Notice of Intent

Type of Action: APD Change

Procedure Description: Engineering Only - Devon Energy Production Company L.P. respectfully requests the following changes to the approved APD: Offline BOP/Stump testing variance request. Batched wells on Red Bull 29 Wellpad 2. Please see attached Break Test Variance_Offline BOP variance request document.

Section 2 - Blowout Preventer Testing Procedure

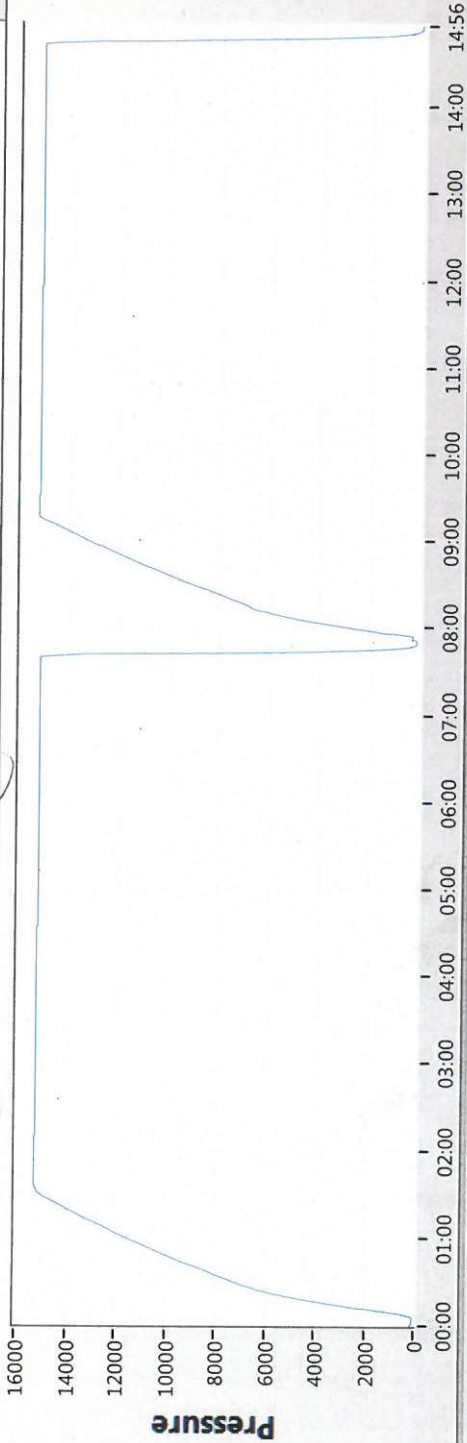
Devon Energy requests to only test BOP connection breaks after drilling out of surface casing and while skidding between wells which conforms to API Standard 53 and industry standards. The initial BOP test will follow 43 CFR 3172, and subsequent tests following a skid will only test connections that are broken. This test will at minimum include the Top Pipe Ram, HCR, Kill Line Check Valve, QDC (quick disconnect to wellhead) and BOP shell of the 10M BOPE to 5M for 10 minutes. Additional pressure testing is required for pressure-containing and pressure-controlling connections when the integrity of a pressure seal is broken. If a break to the flex hose that runs to the choke manifold is required due to repositioning from a skid, the HCR will remain open during the shell test to include that additional break. The variance only pertains to intermediate hole-sections. This variance will meet or exceed 43 CFR 3172 per the following: Devon Energy will perform a full BOP test per 43 CFR 3172 before drilling out of the intermediate casing string(s) and starting the production hole, testing the Annular during initial BOP testing to a minimum of 70% RWP and higher than MASP, and pressure testing at a 21-day interval frequency. The BLM will be contacted 4hrs prior to a BOPE test. The BLM will be notified if and when a well control event is encountered. In the event break testing is not utilized, then a full BOPE test would be conducted.

Devon Energy requests to perform offline BOP stump testing and offline BOPE testing. All pressure-containing and pressure-controlling seals will be tested either online or offline as denoted in the table below and per BLM approval during initial BOP test following test pressure requirements set forth in 43 CFR 3172. Remaining components not tested offline or on the stump will be tested within 72-hours when the BOP is connected to the wellhead. If stump testing exceeds 72-hour window prior to connecting to the wellhead, the BLM will be notified and either stump testing restarted, or the BOP being tested online. The BLM will be contacted 4hrs prior to a BOPE test. The BLM will be notified if and when a well control event is encountered. In the event stump testing is not utilized, then a full BOPE test would be conducted.

Devon requests offline BOPE testing for the following components: Upper Rams, Blind Rams, Kill Valves, Choke Valves, and Annular

Annular Preventer will be tested to minimum of 70% RWP and higher than MASP during initial BOP test

Pressure testing is required for pressure-containing connections if the integrity of a pressure seal is broken during a break test

All Previous COAs Still Apply. Variance request procedure is approved as written, please see below general conditions for variance.

- BOPE Break Testing is ONLY permitted for 5M BOPE or less. **(Annular preventer must be tested to a minimum of 70% of BOPE working pressure and shall be higher than the MASP)**

- BOPE Break Testing is NOT permitted to drilling the production hole section.
- Variance only pertains to the intermediate hole-sections and no deeper than the Bone Springs formation.

Operator has been **(Approved)** to test the BOPE offline.

Online BOPE testing should commence within 72 hours of offline BOPE testing completion. Notify the BLM if interval exceeds 72 hours.
